Planning Commission Packet

STAFF REPORT

SUBJECT: Planning File – Gas Station/Convenience Store (DR 23-02)
Continuation of August 21, 2023, Hearing

RE: Additional Submittal Materials for
Proposed Automobile Service Station
File Number DR 23-02

Proposed Building Design

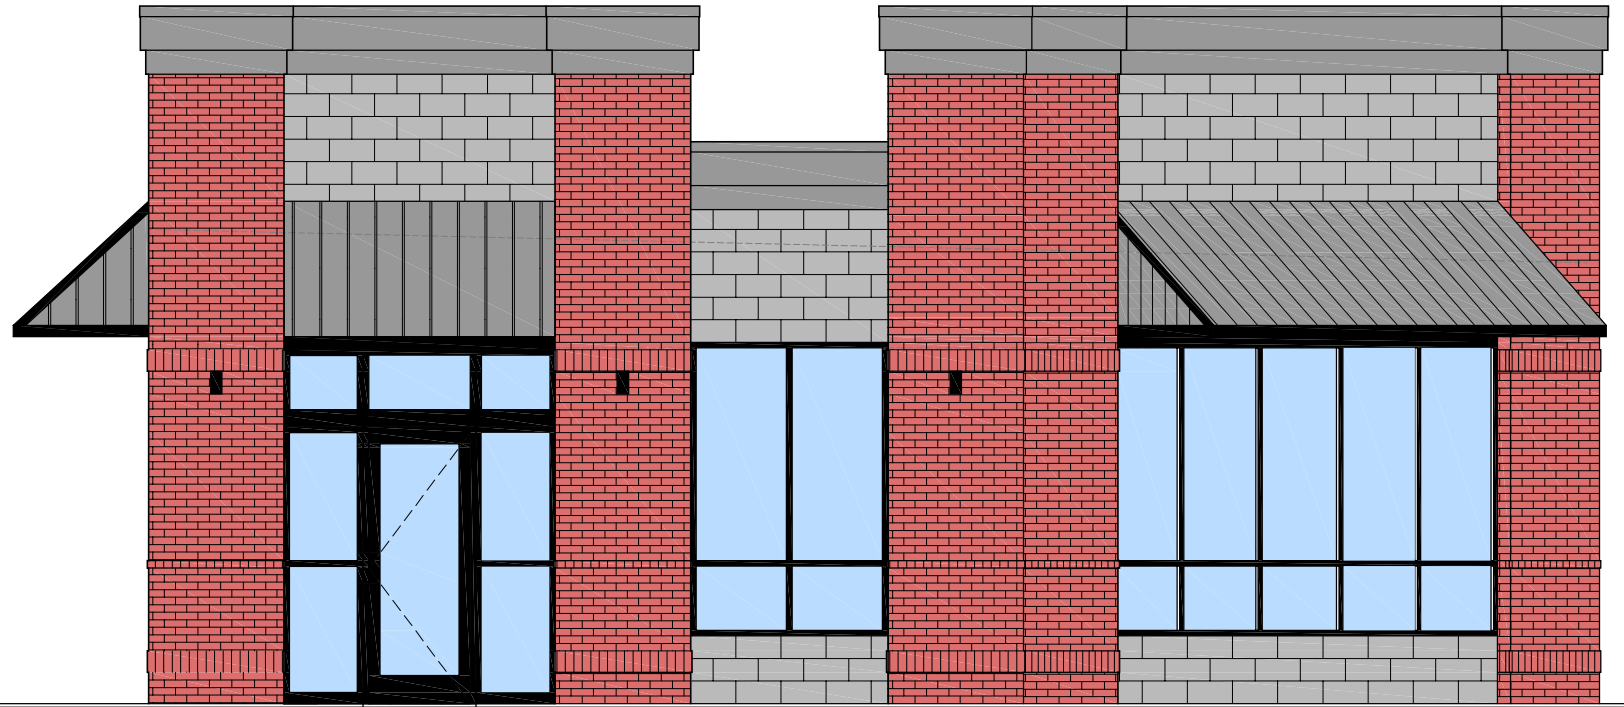
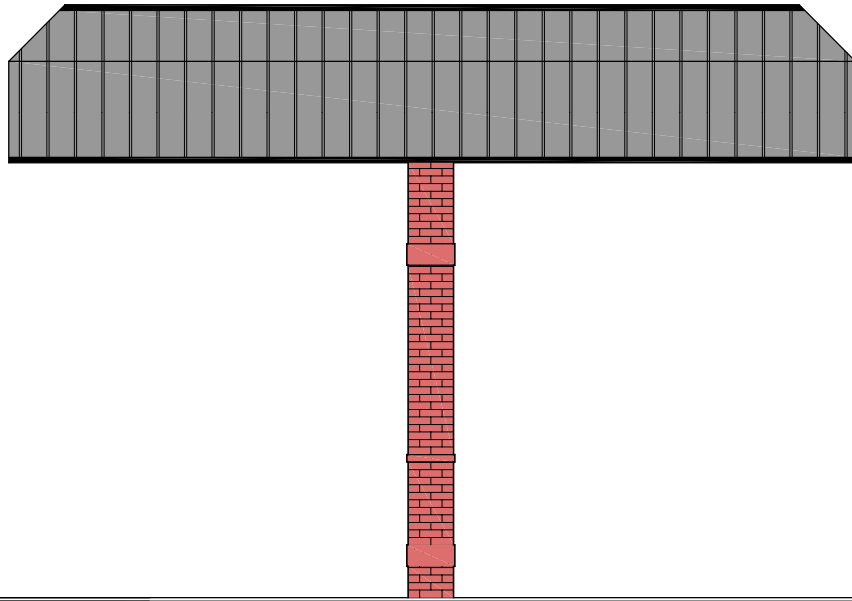
To assist the Planning Commission in their discussion of Section 10.46.050(E)(3) standards, the applicant has submitted street view pictures of the 9 commercial structures which front Maple Street within the Central Business District. Pictures of buildings which were designed for residential use are not included in the submitted handout.

The pictures of the existing commercial structures demonstrate that there is a wide range of architectural styles, building materials, and location of windows and doors in the Central Business District. At the August meeting, several Commission members indicated that they would prefer windows to be placed on both sides of the proposed door facing Maple Street. The attached floor plan and east building elevation indicate that this entrance has been revised to include a traditional swinging door with windows located on both sides of the entry. The revised entrance is also recessed into the structure, similar in character and design of the building entrances at 120 N Maple Street, and 150, 190, and 240 S Maple Street. To help visualize how each side of the proposed building will appear, colored elevations have been prepared and submitted for review.

1 FRONT ELEVATION

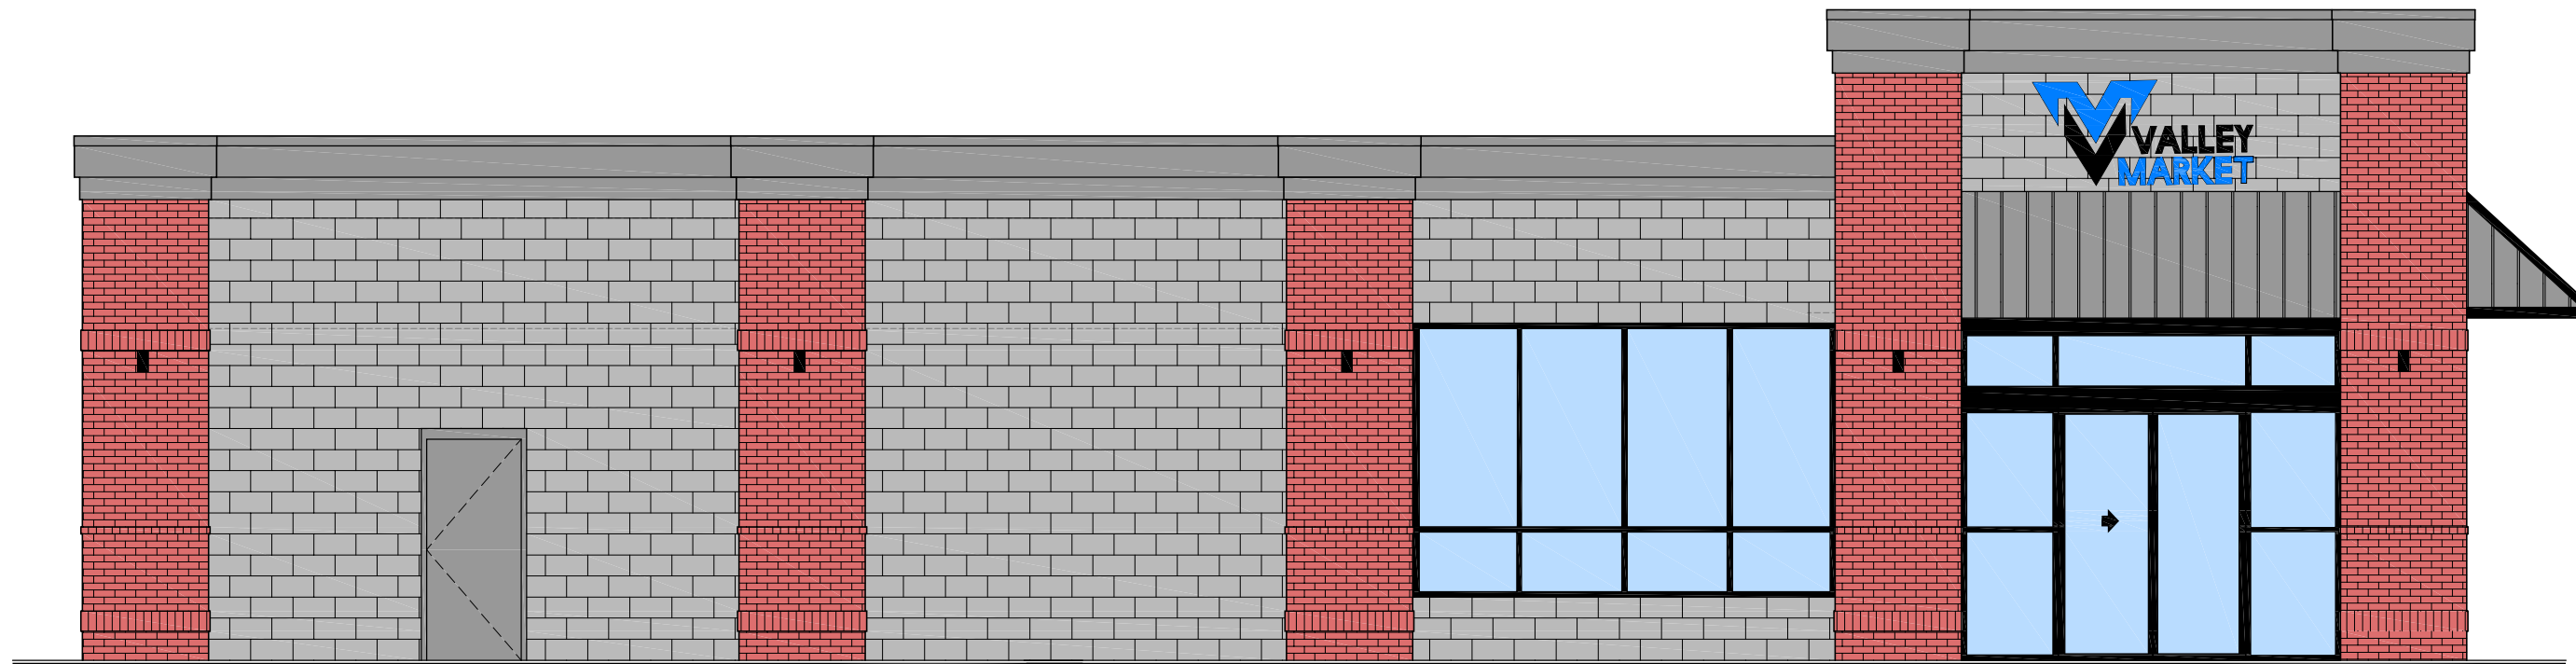
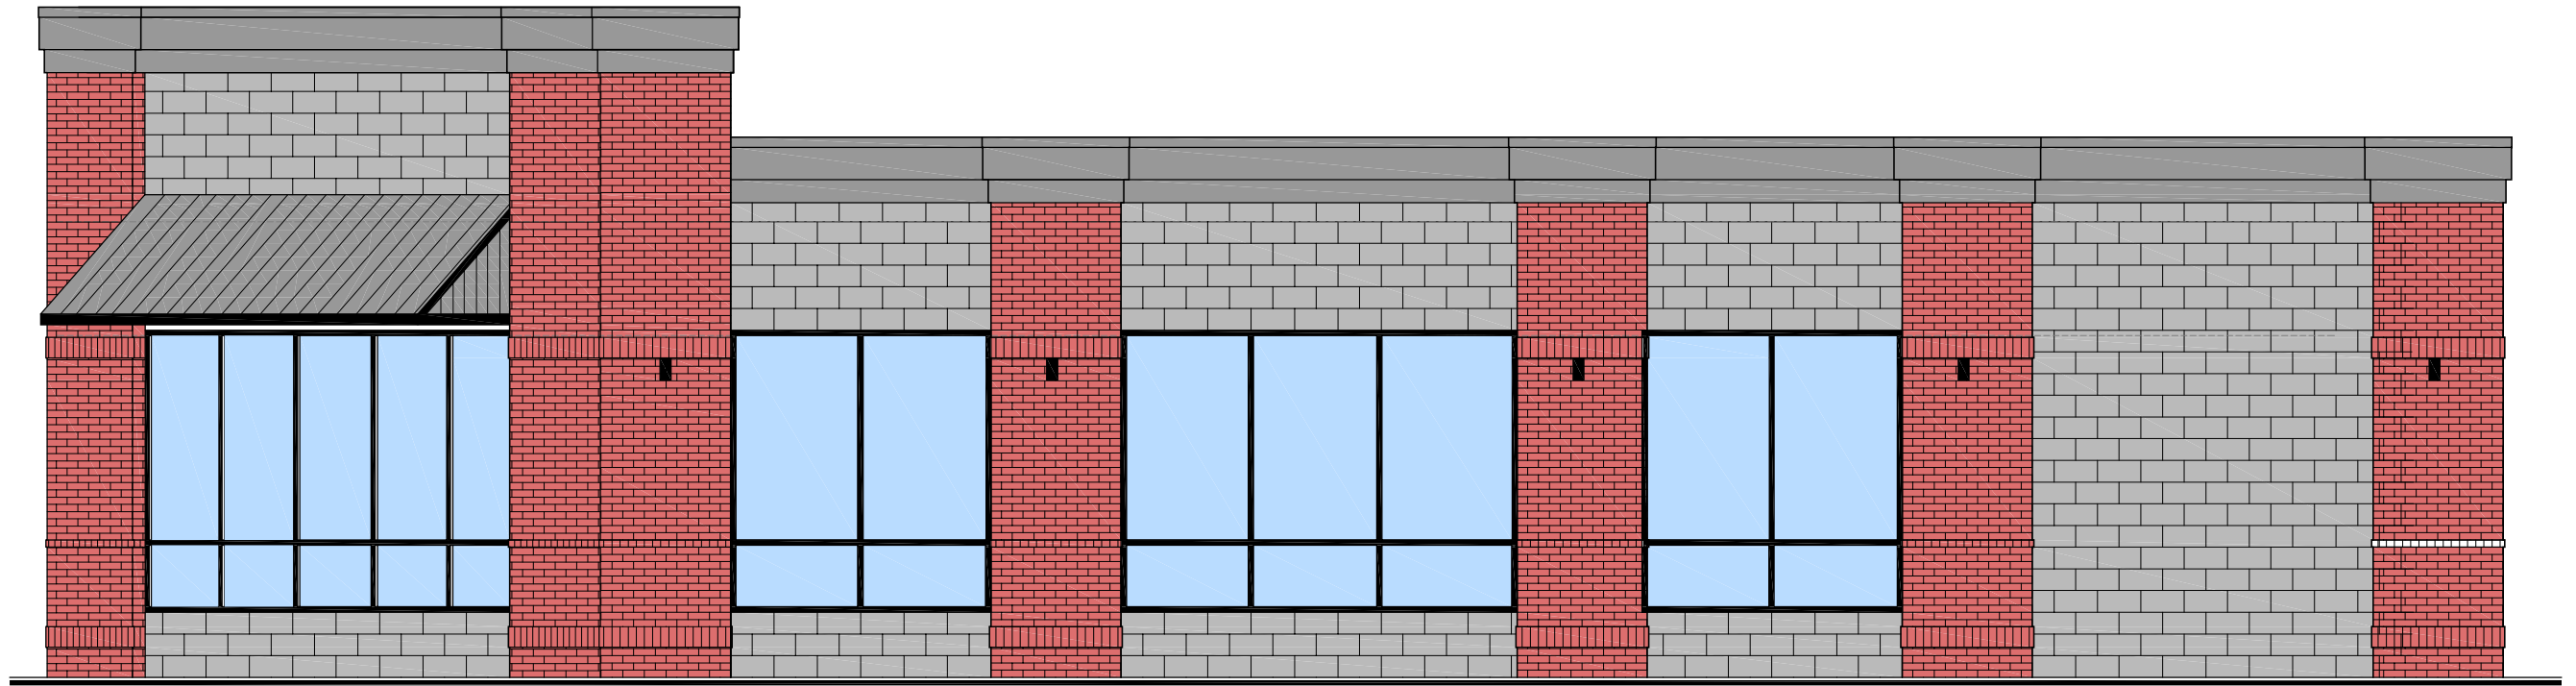
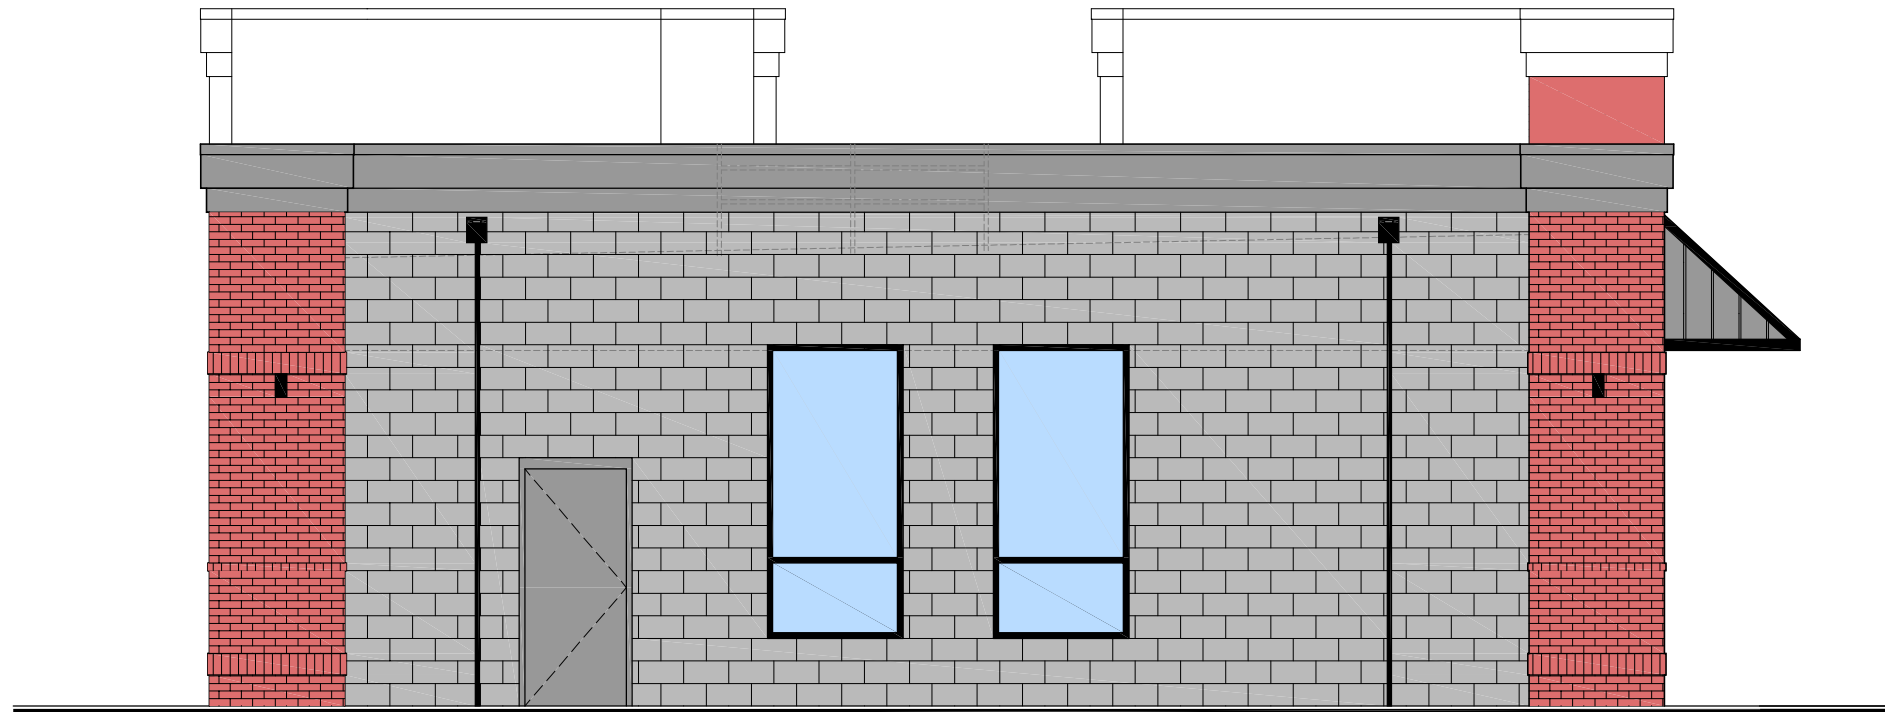
- A. The revised plans for the September meeting show a building entrance along Maple Street with window treatment bordering the door. Based on the submitted photos, the applicant believes this entrance is similar to other entrances along Maple Street. If the Commission agrees this design is “. . . similar in character and design with existing structures” then the building complies with the design provisions Section 10.46.050(E).

Regarding subsection (B), judging design is, at best, subjective. Unlike prior designs, there is now an entrance on Maple Street and significantly more window treatment.

- 1. The building exterior shall conform to submitted elevation plans submitted for the September 7, 2023, incorporating the revised Maple Street entrance and exterior finish.
